February 7, 2019

**Re: Initial Submission Review - Murphy Creek East CSP No. 1 – CSP and Plat**  
Application Number: **DA-1250-41**  
Case Number(s): **2019-4001-00**

## *Initial Submission Review*

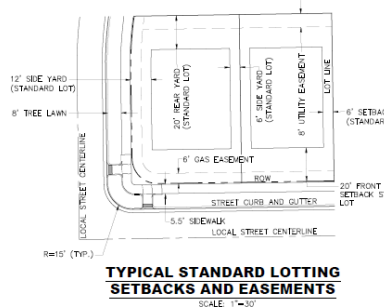
D. Please include a data table illustrating the types and sizes of lots being proposed. Additionally, for tracking purposes, a matrix will be required indicating which lots are small lots versus standard lots.

Sample table graphic is provided.

E. Provide typical lot layout, as illustrated in the graphic provided.
